**Results of the
Comprehensive Performance Evaluation
of the
Hardin Wastewater Treatment Facility
May 28-29, 2015
by
Montana Department of Environmental Quality
Water Pollution Control State Revolving Fund Program
Helena, Montana**

Hardin, Montana
Comprehensive Performance Evaluation
May 28-29, 2015

**FIGURE 2. Hardin, MT Wastewater Treatment Plant 2015
Major Unit Process Evaluation (1980 Design Flow 1.0 MGD)**

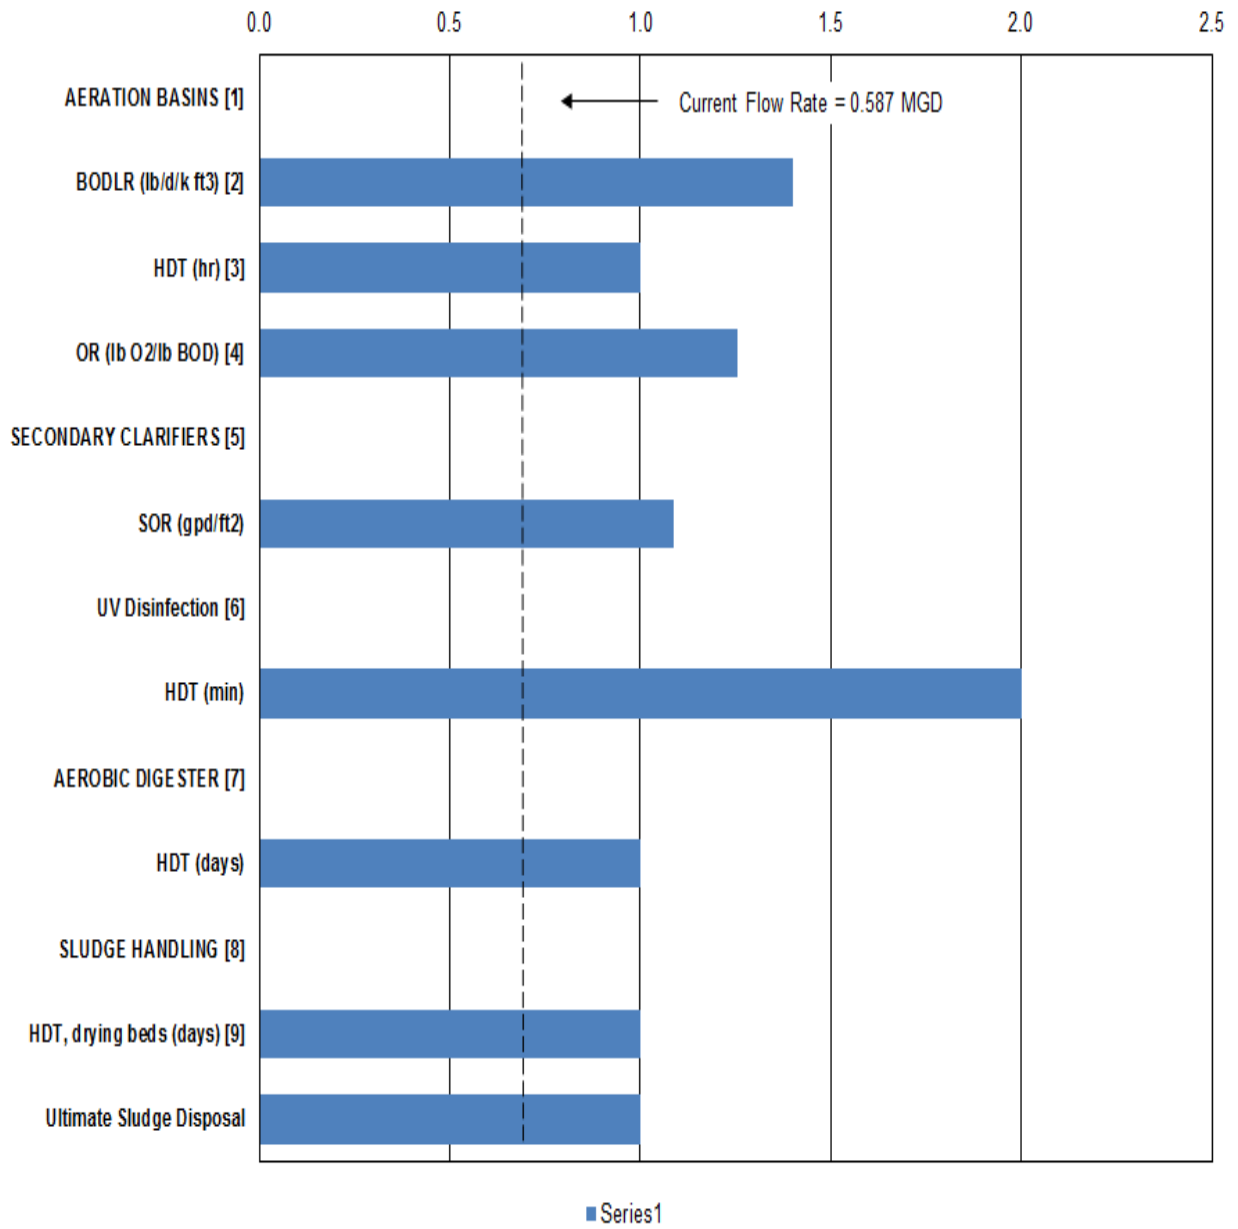
To assess the plant capability relative to various loadings a performance potential graph (PPG) was developed. The assessed capability of the plant to meet desired performance is depicted in Figure 2. The major unit processes and evaluation parameters are listed on the left scale, and the scale of influent flows is listed along the top. The vertical broken line depicts the current flow to the facility. The shaded bars depict the evaluation team's rated capabilities of the plant treatment units. When interpreting the graph, it is important to remember that the projected capability represents the evaluation team's judgment concerning performance capability taking both design and operational parameters into account.

Summary: The plant unit processes were all rated adequate to provide the desired level of performance at current flows.

Oxidation Ditch: The first bar graph evaluates OD capacity (#BOD/1000 ft³) for treating the organic load by supplying the necessary volume (HDT) and oxygen (#O₂/#BOD) in the basins. These bars are located directly beneath the bars representing current BOD loading conditions: BODLR, HDT and OR (BOD Loading Rate, Hydraulic Detention Time and Oxygen Requirement, respectively). The capacity of the OD, organic and hydraulic loading, and Oxygen Supply System are adequate to treat current waste loads and appear to be adequate to design flows and loads.

Secondary Clarifiers: The clarifiers are rated beyond the current plant flows and seem adequate to handle the design capacity of 1.0 mgd.

Ultra-violet (UV) Disinfection: The UV system was rated past current flow, to design plant flows.

Aerobic Digester: The digestion process was rated adequate for the current level of sludge production, but might be limited in capacity relative to design loads and solids production.
